On behalf of RVA YIMBY, we are writing in support of Ordinance 2023-346 authorizing the special use of the properties at 901 North 36th Street and 909 North 36th Street in the 7th District for up to 10 single family homes.

Project Response: Ord. No. 2023-346

Address: 901-909 N. 36th St.

SHEET:
A5.2

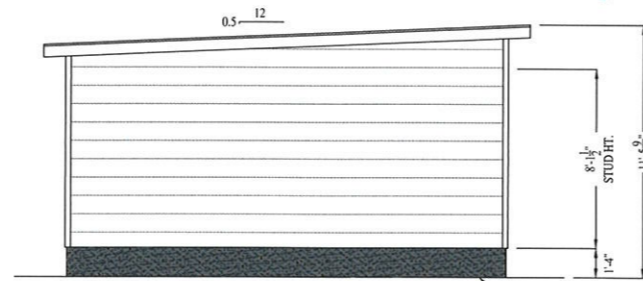
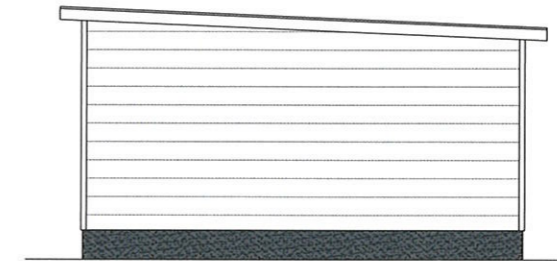
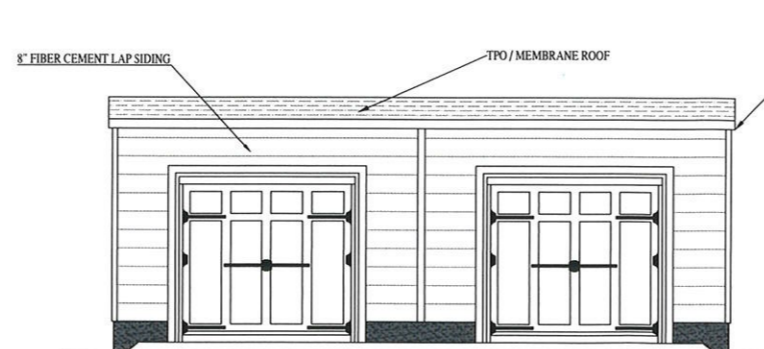
*PROVIDE ROOM
IN GARAGES
FOR 'STUFF'*

*THINK ALLEY
ELEVATION
WILL CHANGE
SIGNIFICANTLY.*
